Intersection ID: 28253	Main Street: EASTON_GREY_LN	Cross Street: PEMSWOOD_ST	Location:	SE
ADA ID: A0386A56B301	Ramp Type: PerpDiag	Initial Pass/Fail: Fail	Overall Compliance: No	Severity Score: 13.75

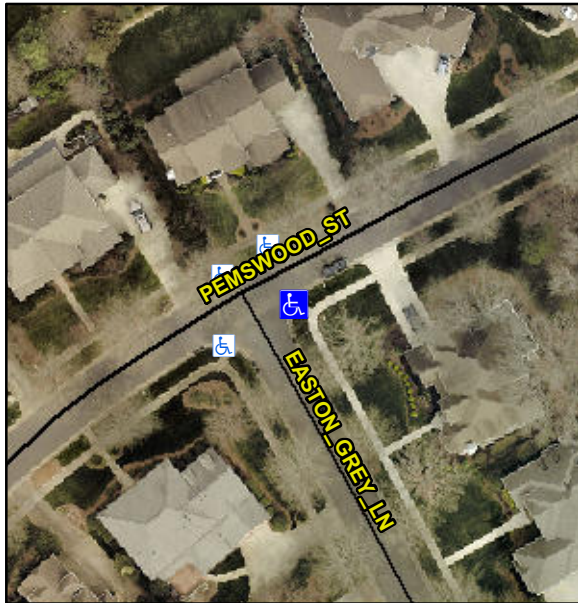
R304.2.2, R304.5.3

Compliance	Description	Data	Compliance	Description	Data
N/A	Ramp Length (in)	100.0	No	Ramp Slope (%)	11.5
Yes	Ramp Width (in)	54.0	No	Ramp XSlope (%)	2.2
N/A	Flare Type LT	N/A	N/A	Flare Type RT	N/A
N/A	Flare Slope LT (%)	N/A	N/A	Flare Slope RT (%)	N/A
N/A	Flare Traversable LT?	N/A	N/A	Flare Traversable RT?	N/A
N/A	Landing Length (in)	N/A	N/A	DWS Provided?	N/A
N/A	Landing Width (in)	N/A	N/A	DWS Contrast?	N/A
N/A	Landing Slope (%)	N/A	N/A	DWS Length (in)	N/A
N/A	Landing X Slope (%)	N/A	N/A	DWS Full Width?	N/A
N/A	Landing Curb? (Y/N)	N/A	N/A	DWS Offset (in)	N/A
N/A	Shared Landing?	N/A			
N/A	Gutter Ponding?	N/A	N/A	Gutter Slope (%)	N/A
N/A	Gutter Lip Ht (in)	N/A	N/A	Gutter X Slope (%)	N/A
N/A	Painted X Walk1?	No	N/A	Painted X Walk2?	No
	X Walk 1 Direction	To N		X Walk 2 Direction	To W
N/A	X Walk 1 Width (in)	N/A	N/A	X Walk 2 Width (in)	N/A
	X Walk 1 Slope (%)	1.1		X Walk 2 Slope (%)	1.9
	X Walk 1 X Slope (%)	2.3		X Walk 2 X Slope (%)	2.6

Remove & Replace Curb Ramp With Two New Directional Ramps or Equivalent.
